**UNITED STATES DEPARTMENT OF COMMERCE
National Oceanic and Atmospheric Administration
NATIONAL OCEAN SERVICE**

Re. Control No.: 142793

We are responding to your email dated Tuesday, 30 December 2008, with the subject "Department of Commerce, Request for Additional Information Concerning Application for a License Amendment, Control 142793."

SUBJECT: DECONTAMINATION PROCEDURE (REFERENCE MAIL CONTROL NUMBER: 220449)

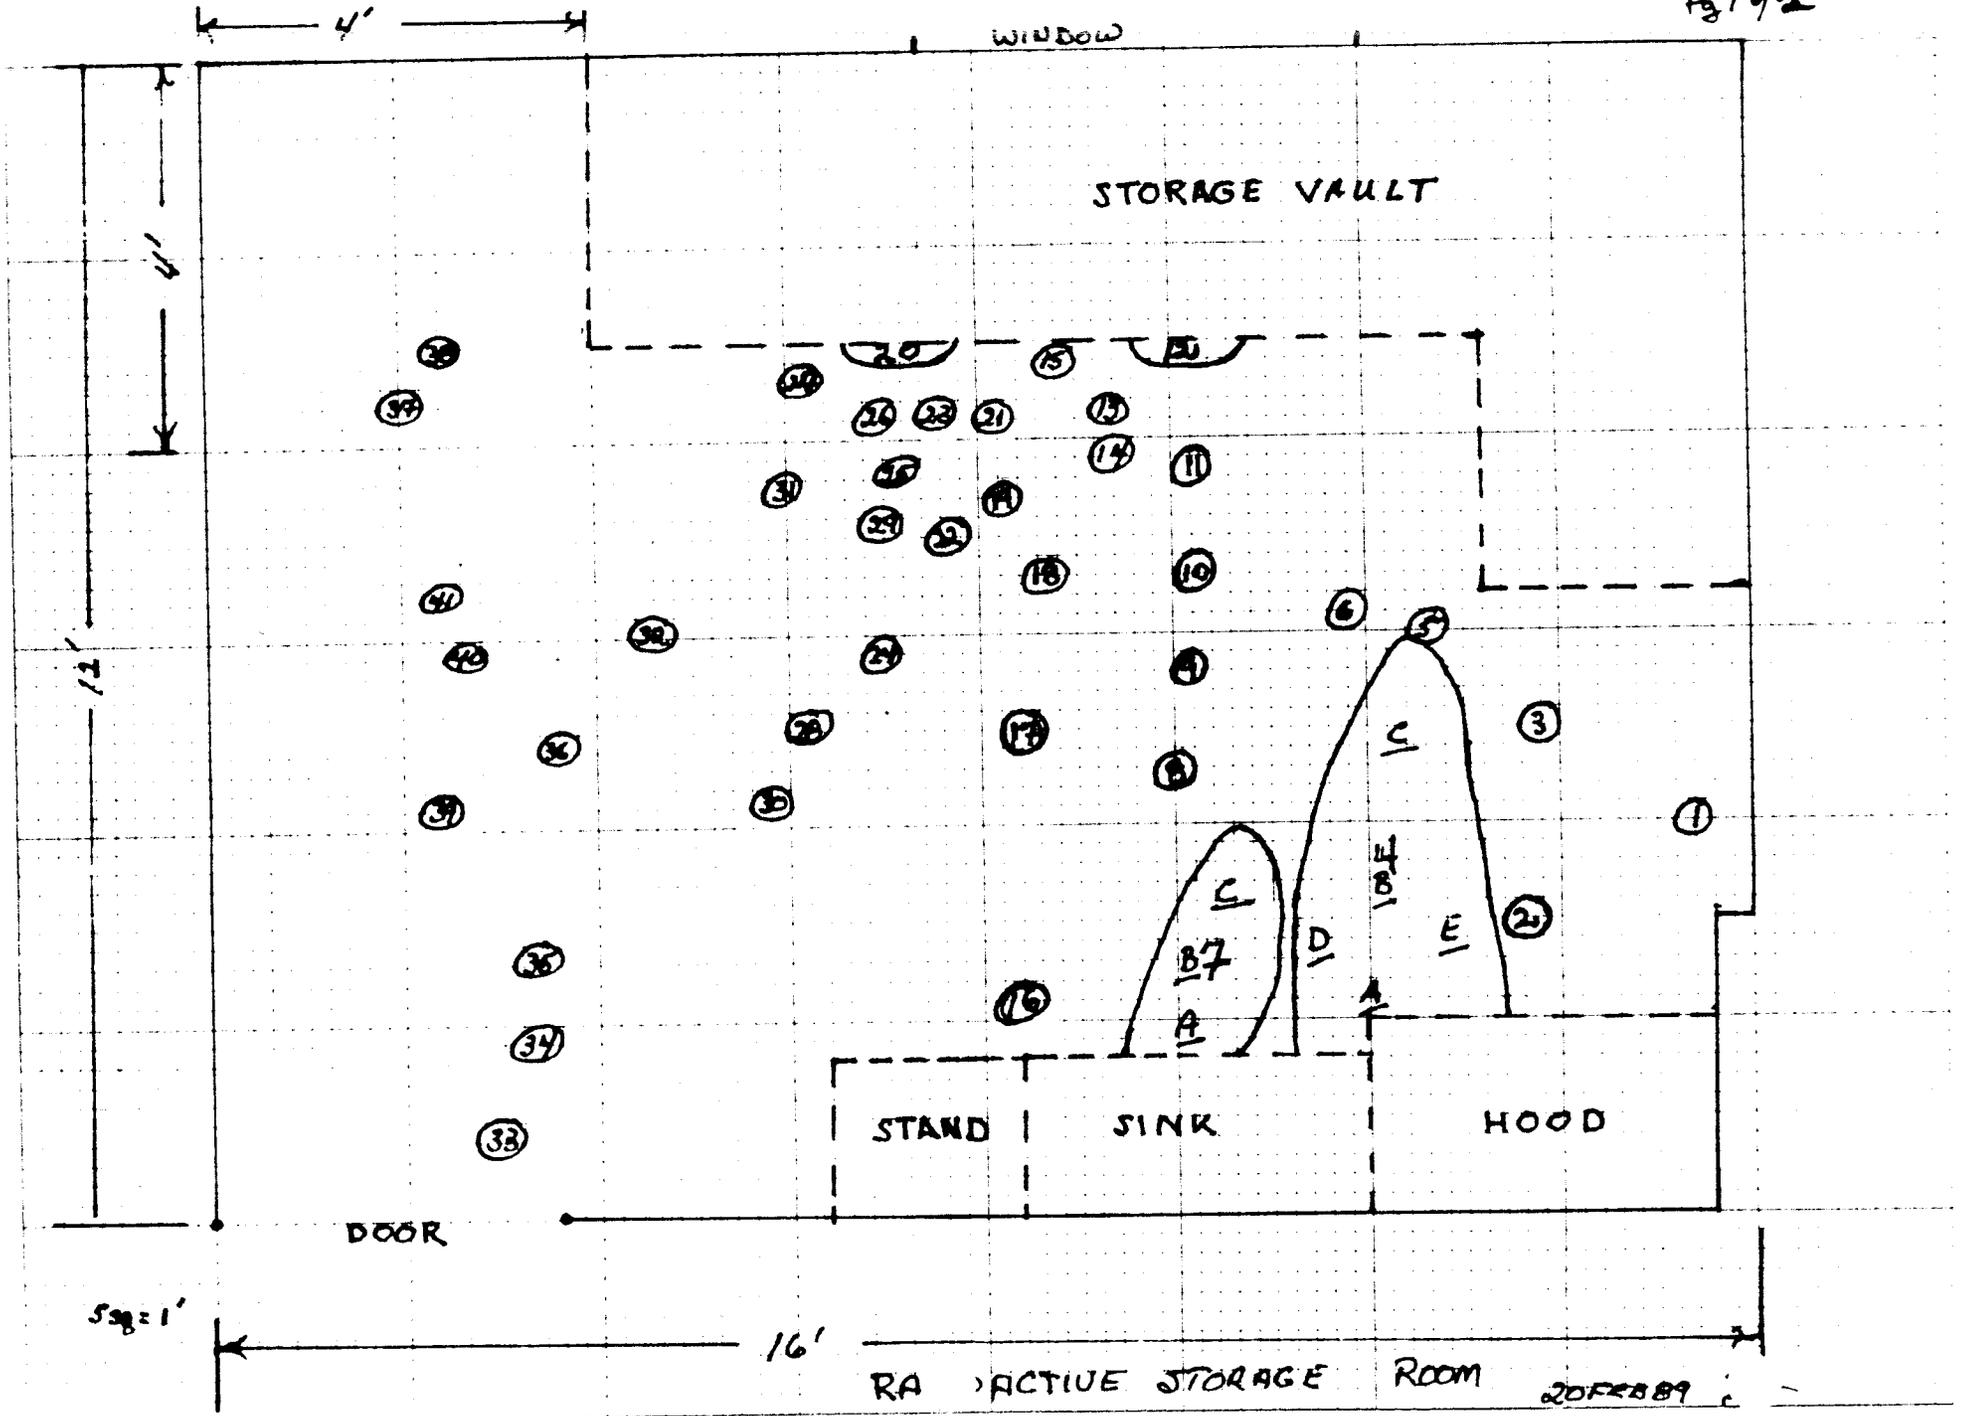
Enclosed is a drawing of the radioactive spots on the floor of the room where the isotope vault was previously located. Also, the readings obtained with a GSM-10 survey meter are included. As we discussed on the phone, I have secured the room and will wait until I hear from you to proceed with the decontamination procedure.

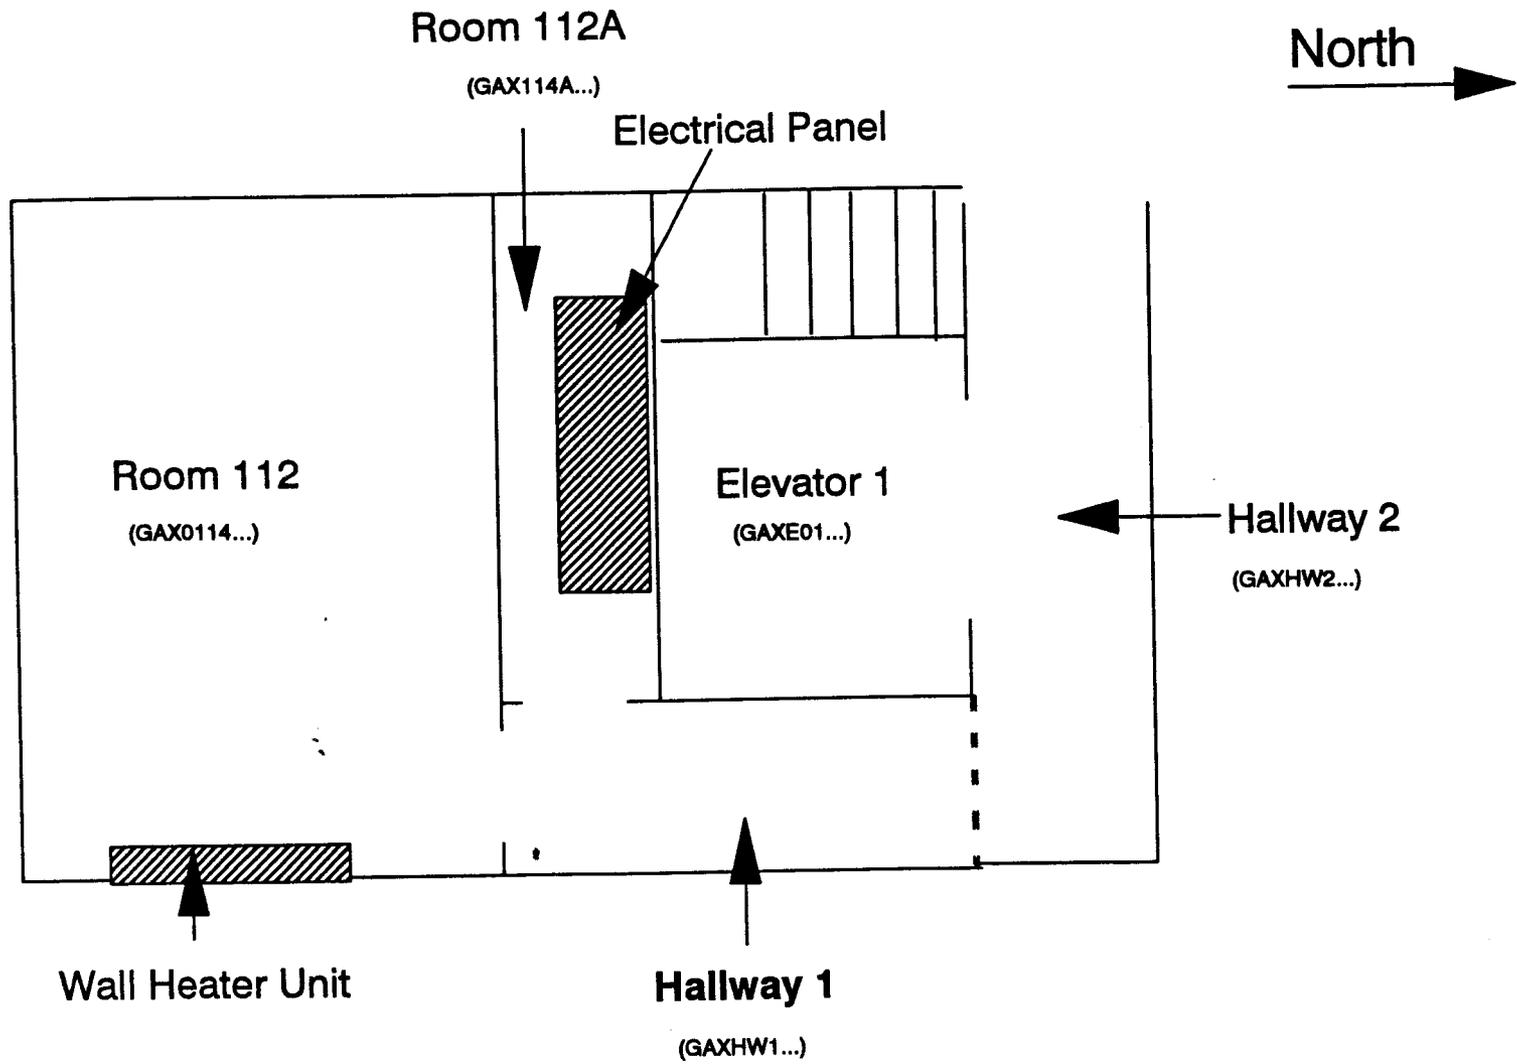
Regarding the contaminated drain pipe in the wall of room 112, the SEG team obtained two measurements at the end of the pipe: one was 4,839dpm, the other 5,240dpm (for an average of 5,040). Clearly, this is not statistically different than 5,000dpm. This activity is well below the acceptable maximum (15,000 dpm) for an area not exceeding 100 cm² (the cross sectional area of the pipe is about 11cm²). There was no removable activity. Given these circumstances, and the fact that, as Cs¹³⁷, even 5240dpm would decay to below 5000dpm in 2 years, I do not believe it is necessary to remove the pipe.

There is a small spot in the hall that gave a reading of 31,590dpm/100cm², about twice the acceptable level of unremovable contamination. This spot is less than 2 inches across, (i.e., is completely covered by the GM pancake detector), and has no removable activity. It is located just outside the door of room 112, near the wall. The SEG team said they did not have time to remove it and stay within the agreed time to complete their contract (which specified only the floor of room 112). Since this spot is in a hall that is used only for access to room 112, and furthermore, is not in a heavily trafficked portion of the floor, I'm wondering if we could allow it to remain? If not, what are the guidelines for removing it ourselves?
